Appendix J

Written Agency Public Comments

**REF: *EIS/EIR for the Metro Gold Line Foothill Extension Azusa to Montclair
Los Angeles and San Bernardino Counties, California***

FIGURE 3

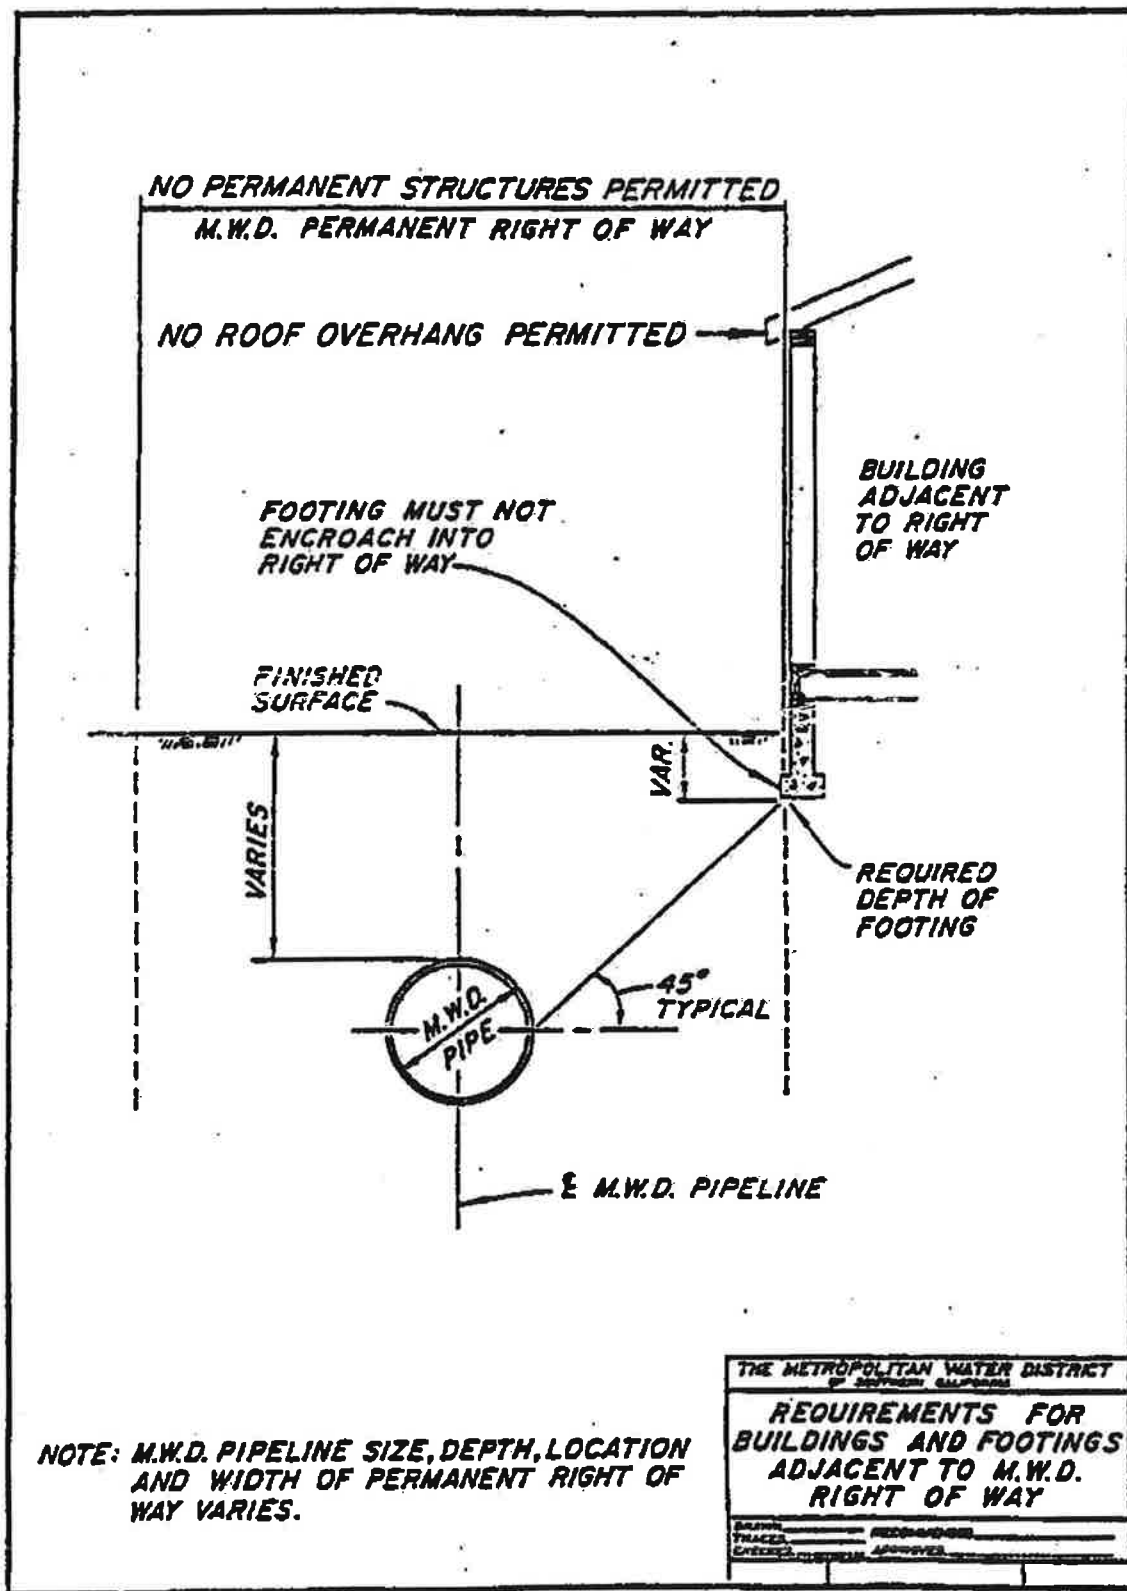
d. Deep-rooted trees are prohibited within Metropolitan's fee properties and/or easements. Shallow-rooted trees are the only trees allowed. The shallow-rooted trees will not be permitted any closer than 15 feet from the centerline of the pipeline, and such trees shall not be taller than 25 feet with a root spread no greater than 20 feet in diameter at maturity. Shrubs, bushes, vines, and ground cover are permitted, but larger shrubs and bushes should not be planted directly over our pipeline. Turf is acceptable. We require submittal of landscape plans for Metropolitan's prior review and written approval. (See Figure 3).

FIGURE 4

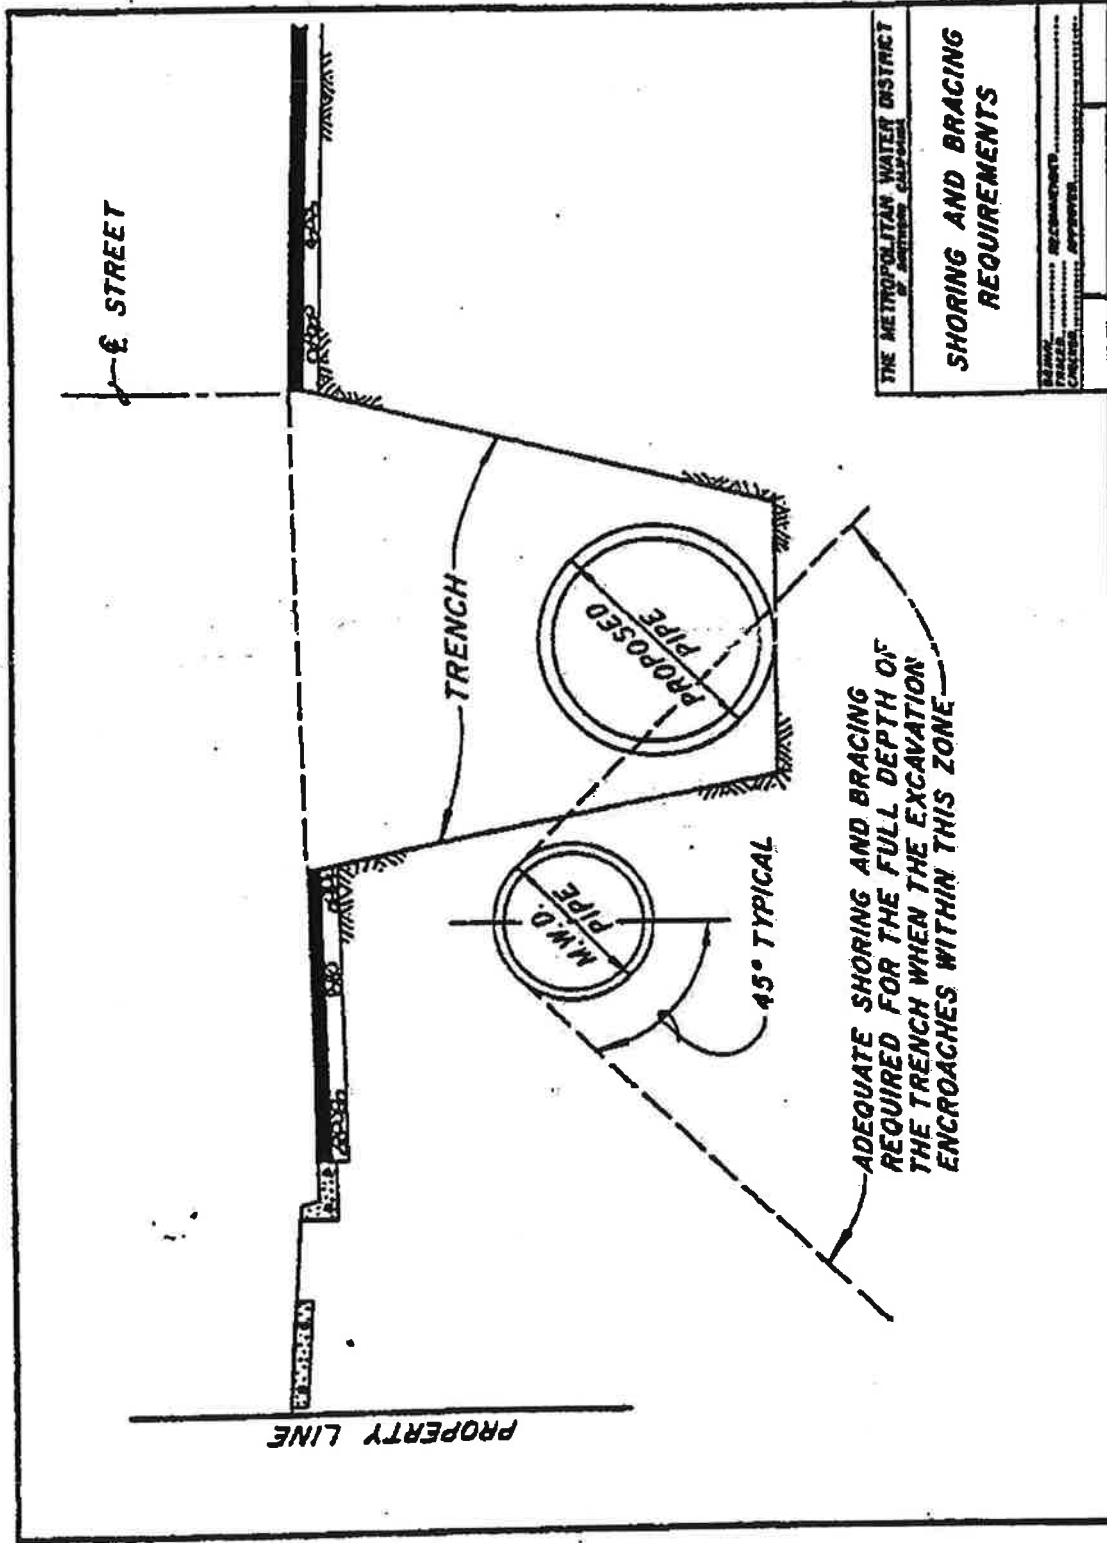
k. Adequate shoring and bracing is required for the full depth of the trench when the excavation encroaches within the zone shown on Figure 4.

FIGURE 5

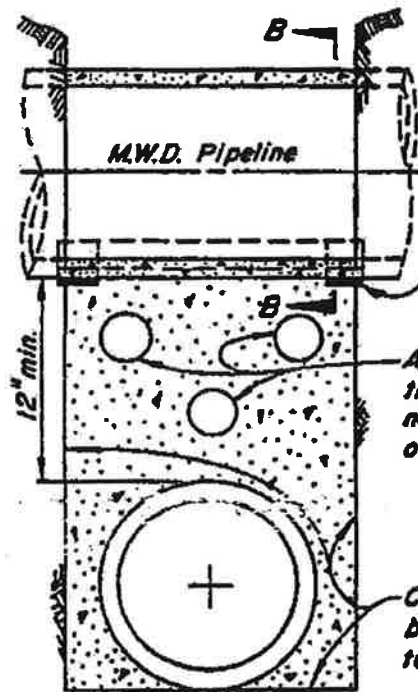
Metropolitan requires that perimeter fencing of its fee properties and facilities be constructed of universal chain link, 6 feet in height and topped with 3 strands of barbed wire angled upward and outward at a 45 degree angle or an approved equal for a total fence height of 7 feet. Suitable substitute fencing may be considered by Metropolitan. (Please see Figure 5 for details).

C-9547

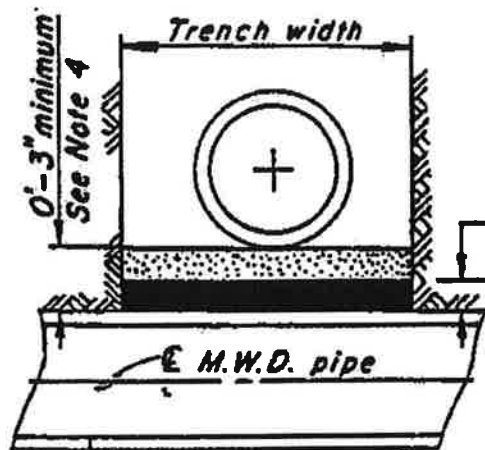
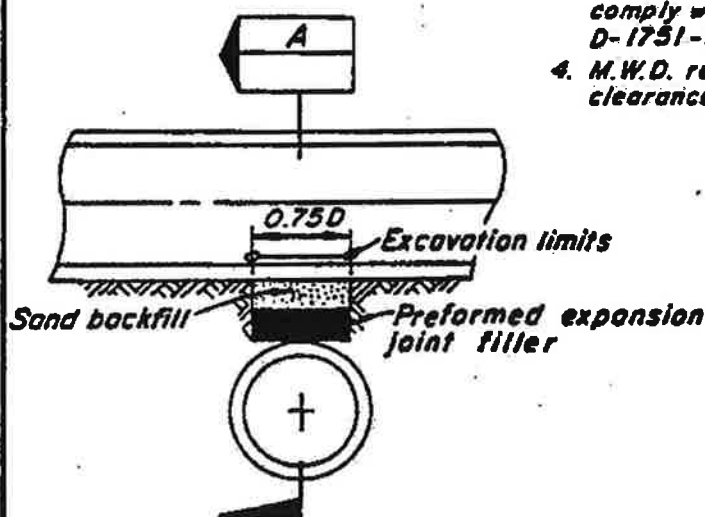
c. The installation of utilities over or under Metropolitan's pipeline(s) must be in accordance with the requirements shown on the enclosed prints of Drawings Nos. C-11632 and C-9547. Whenever possible we request a minimum of one foot clearance between Metropolitan's pipe and your facility. Temporary support of Metropolitan's pipe may also be required at undercrossings of its pipe in an open trench. The temporary support plans must be reviewed and approved by Metropolitan.
